**Response to NRC Request for Additional Information on
WCAP-16005-NP, Rev. 03, "San Onofre Nuclear Generating
Station Unit 2 RCS Pressure and Temperature Limits
Report"; and WCAP-16167-NP, Rev. 0, "San Onofre
Nuclear Generating Station Unit 3 RCS Pressure and
Temperature Limits Report"**

December 14, 2005

Revision 0

Figure 1: FE Models used in Computing K_{IM} due to Internal Pressure Loading

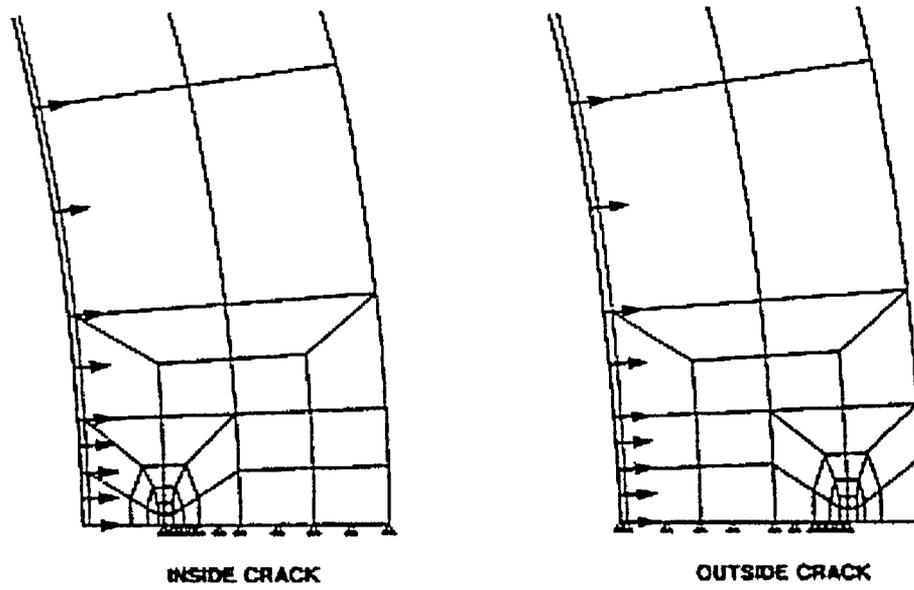
Per your response to action item 21 in RAI 1, if your methodology applies the CE NSSS method for calculating K_{IM} stress intensity values, then your application will need to include a request for an exemption from the requirements of 10 CFR Part 50, Appendix G for P-T limits. The need for an exemption for calculating P-T limits using the CE NSSS method is specified in the fourth paragraph (pages 20- 21) of Section 2.5.4 and in action item 21 (page 27) of Section 5.0 of the SE on topical report CE-NPSD-683, Revision 6, dated March 16, 2001. The CE Owners Group (CEOG) agreed to this requirement in their final version of topical report CE-NPSD-683, Revision 6. The requirement for the exemption is specified in the "Note" on page 5-15 of the topical report.

Per the conditions listed in the safety evaluation for topical report CE NPSD-683 (Reference 4) a request for exemption from the requirements of 10CFR Part 50, Appendix G, is provided in Appendix A of this document.

Figure 1: FE Models used in Computing K_{IM} due to Internal Pressure Loading

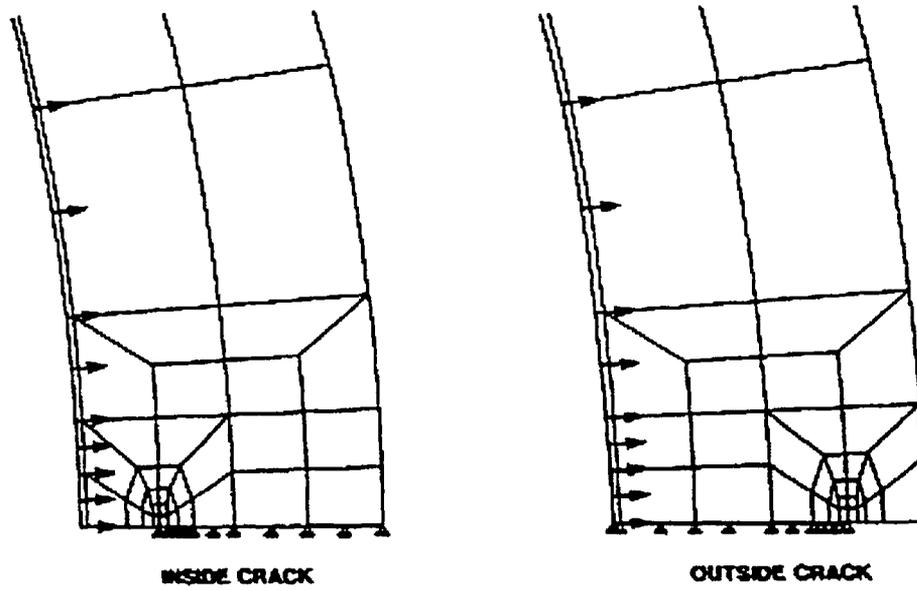
Per your response to action item 21 in RAI 1, if your methodology applies the CE NSSS method for calculating K_{IM} stress intensity values, then your application will need to include a request for an exemption from the requirements of 10 CFR Part 50, Appendix G for P-T limits. The need for an exemption for calculating P-T limits using the CE NSSS method is specified in the fourth paragraph (pages 20- 21) of Section 2.5.4 and in action item 21 (page 27) of Section 5.0 of the SE on topical report CE-NPSD-683, Revision 6, dated March 16, 2001. The CE Owners Group (CEOG) agreed to this requirement in their final version of topical report CE-NPSD-683, Revision 6. The requirement for the exemption is specified in the "Note" on page 5-15 of the topical report.

Per the conditions listed in the safety evaluation for topical report CE NPSD-683 (Reference 4) a request for exemption from the requirements of 10CFR Part 50, Appendix G, is provided in Appendix A of this document.
